WM8962 to WM8962B Migration Document

The WM8962B is a new device succeeding the WM8962. The WM8962B is completely backwards compatible and includes several functional improvements.

This document outlines differences between the WM8962 and WM8962B.

Figure 3 WM8962B Internal Clocking

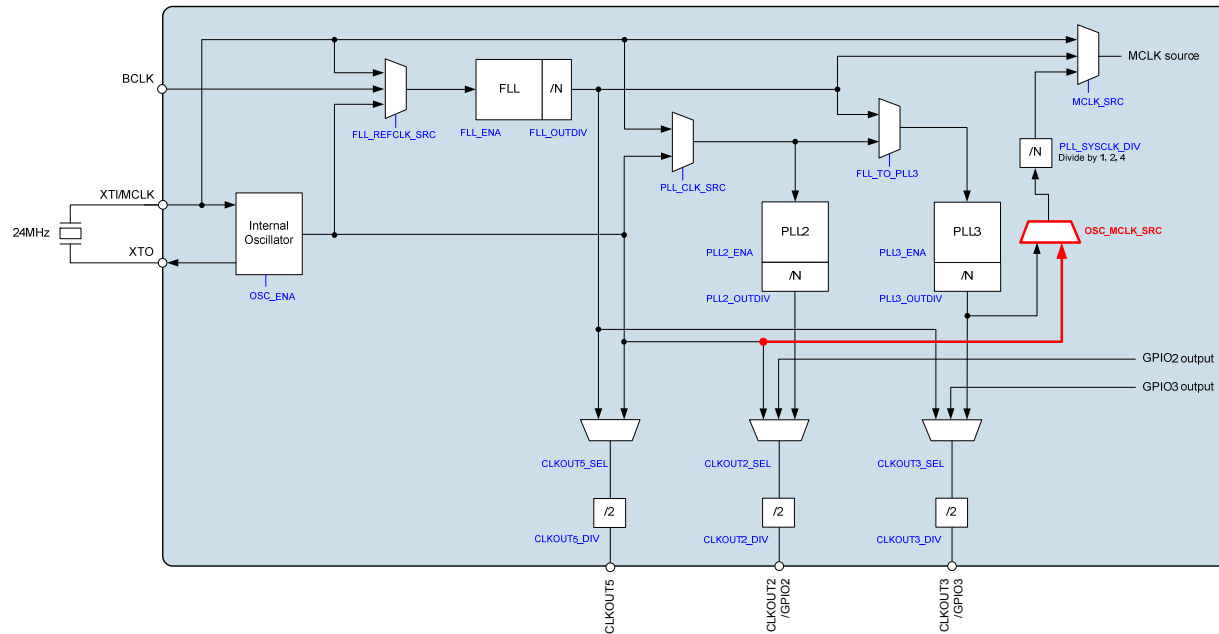
On the WM8962, the internal oscillator must be used in conjunction with the FLL or PLL3 in order to be used as the MCLK source. On the WM8962B a new clock path is provided so that the oscillator can provide the MCLK source without having to enable the FLL or PLL3.

Figure 3 shows the internal clocking diagram for the WM8962B. The features highlighted in red are not available on the WM8962. The new multiplexor is controlled by OSC_MCLK_SRC.

The register control bit OSC_MCLK_SRC is described in the table below.

REGISTER ADDRESS	BIT	LABEL	DEFAULT	DESCRIPTION
R152 (98h) PLL Spare	4	OSC_MCLK_SRC	0	Oscillator or PLL3 MCLK source select 0 = PLL3 1 = Oscillator
